الموضوع : بعثة المتابعة من إيفاد

Feedback requested on the terms of reference for the follow up mission to GSLRP

Terms of Reference for the Follow Up Mission to the GSLRP (SD-630)
DRAFT for REVIEW

Figure 4. Cwsqachange in Cultivated and Irrigated in Gash from 2004 to 2008

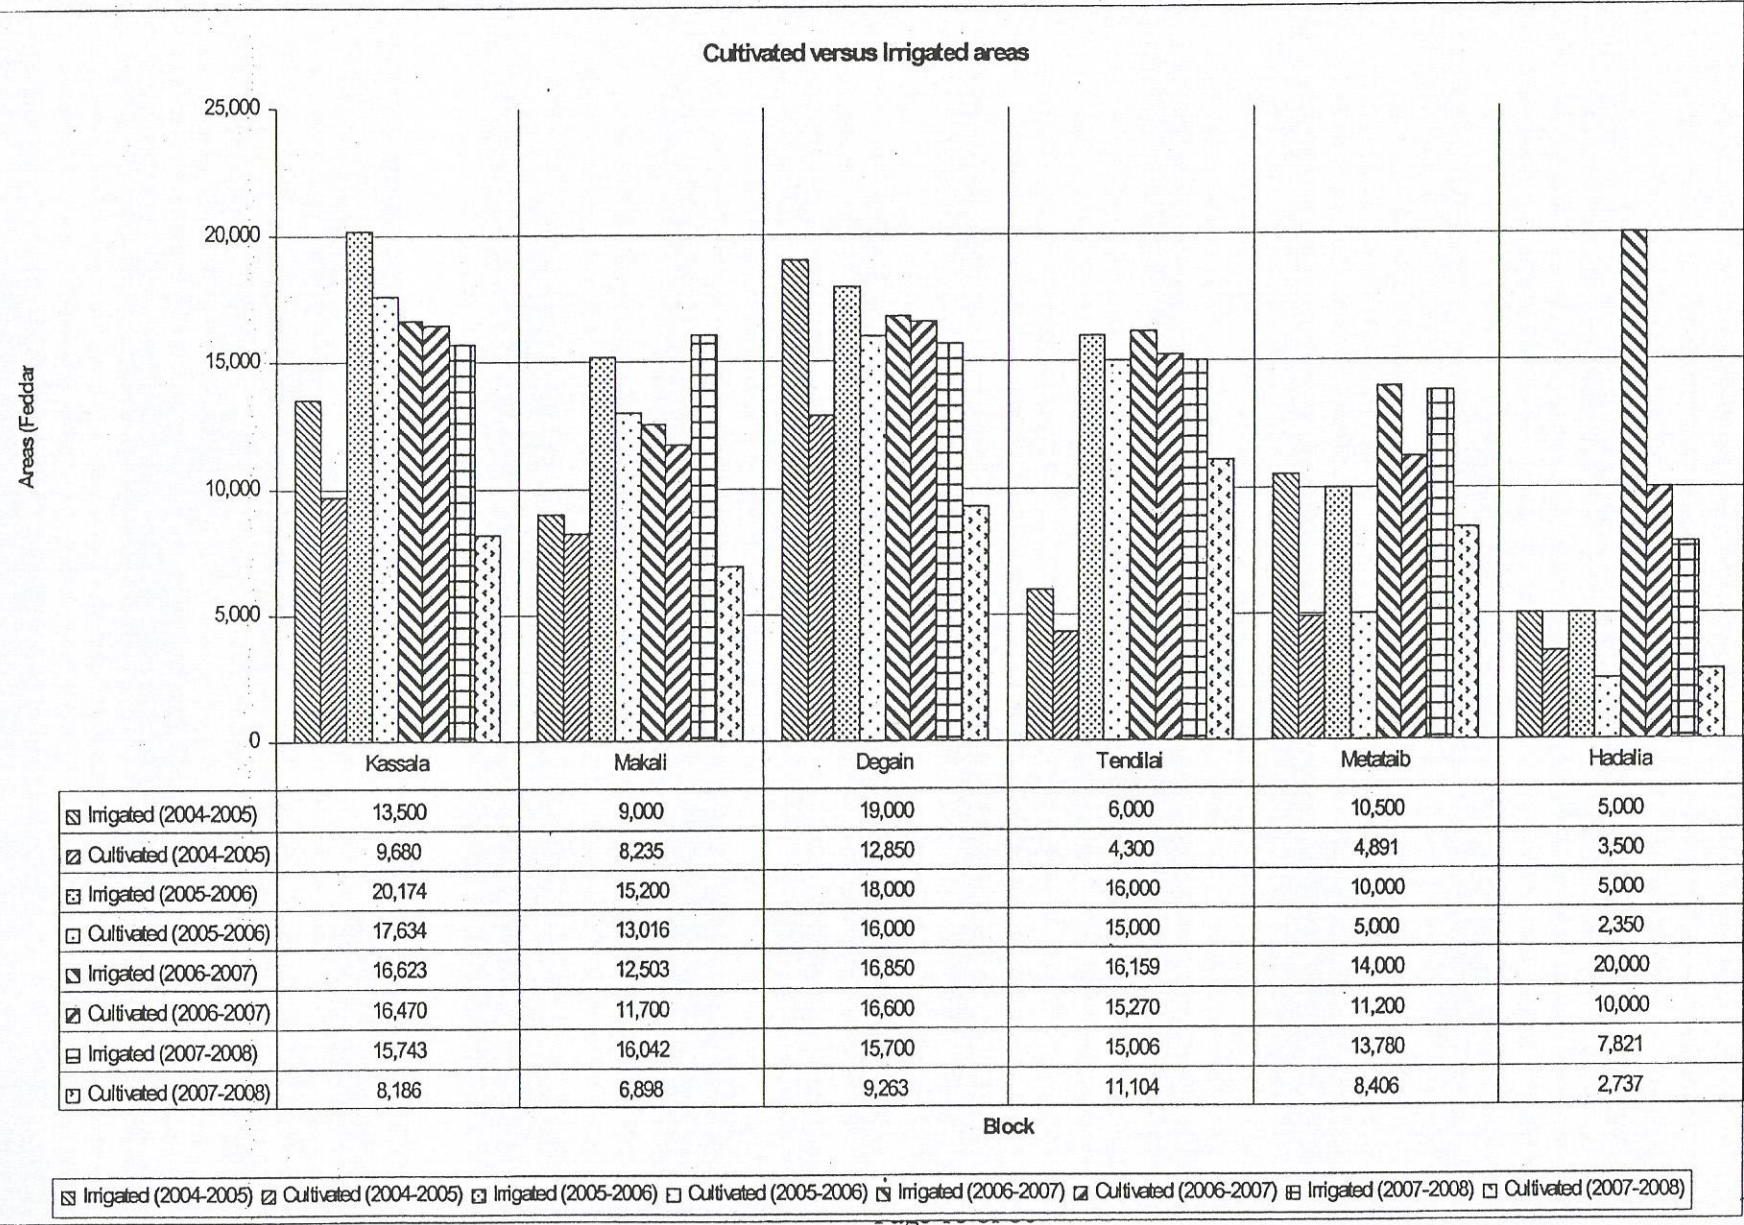
Comment [r5]: Can we consider this an innovation on the part of the GAS staff?
